RENESAS TECHNICAL UPDATE

Product Category	MPU/MCU		Document No.	TN-RZ*-A043A/E	Rev.	1.00
Title	Notes about SSCG		Information Category	Technical Notification		
Applicable Product	See following	Lot No.	Reference Document	See following		
		All

[1] Condition

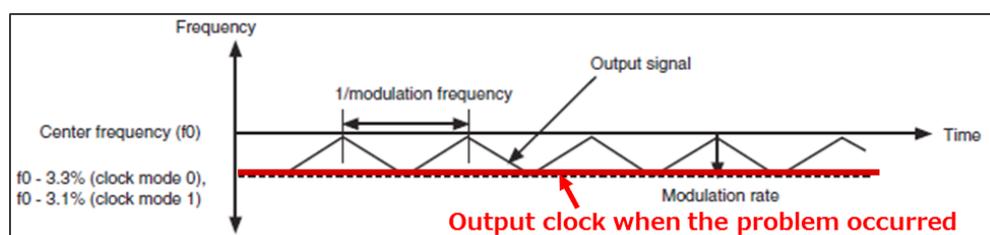
When SSCG is used and fulfill more than one of following conditions.

- The power is supplied in the power on sequence as following order
 - 1) Supply 3.3 volt power and MD_CLKS pin is changed to high level (SSCG ON)
 - 2) Supply 1.2 volt power
- Deep standby mode is cancelled by power on reset and MD_CLKS pin is asserted high level during power on reset period.
- Deep standby mode is cancelled by other than power on reset.

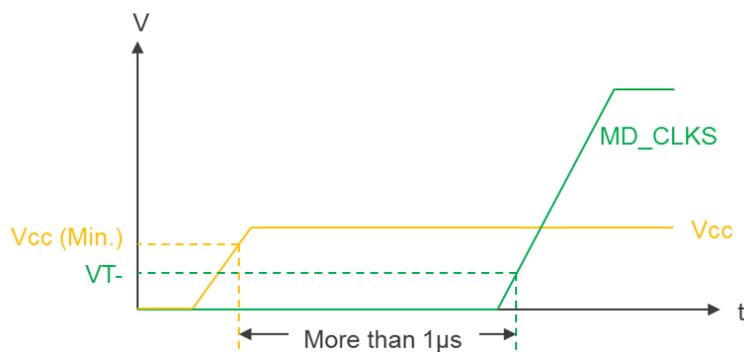
- Please make more than one microsecond between Vcc power on and change timing of MD_CLKS pin to high level. (below figure)

And do not use deep standby mode.

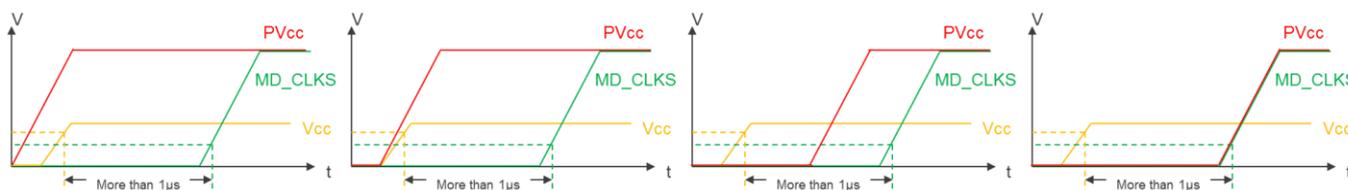
- PVcc power on timing should be at the same time as MD_CLKS pin or faster than MD_CLKS pin. (below figure)

if PVcc power on timing is later than change timing of MD_CLKS pin to high level, it becomes absolute maximum rating violation.
